Request for Information (“RFI”)

Harrison, Town-Village Recreation Center Phase 2
270 Harrison Avenue
Harrison, NY 10528

RFI No. RFI 045 - Pouring Slabs

CONCRETE LONGITUDINAL SECTION @ ASPHALT

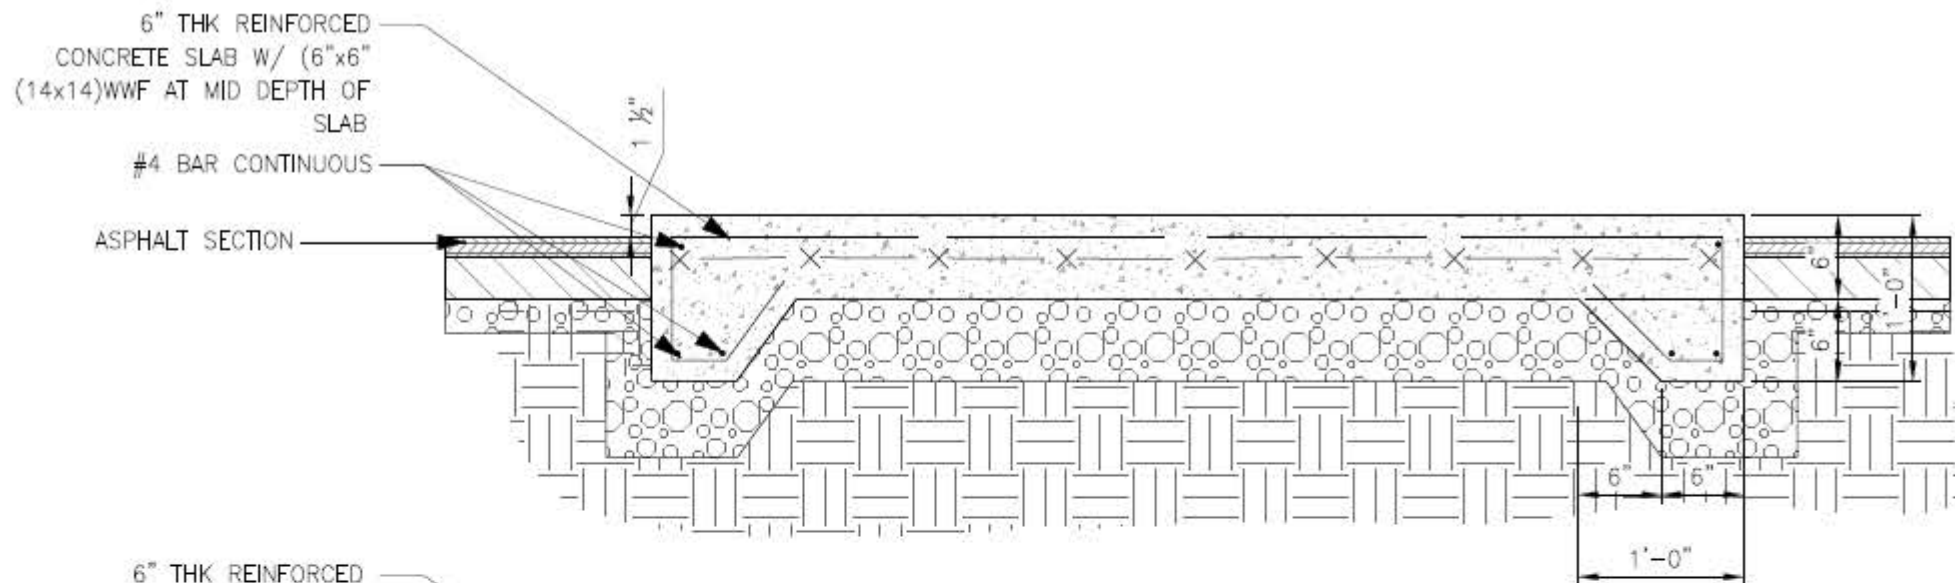
RFI DESCRIPTION: Can you please confirm with the architects if this is a typo in the plans (see attached).
When pouring slabs, we normally use WWF 6x6 W1.4xW1.4 not WWF 6x6 14x14

Confirmed typo. Note to read "WWF 6x6 W1.4 x W1.4"
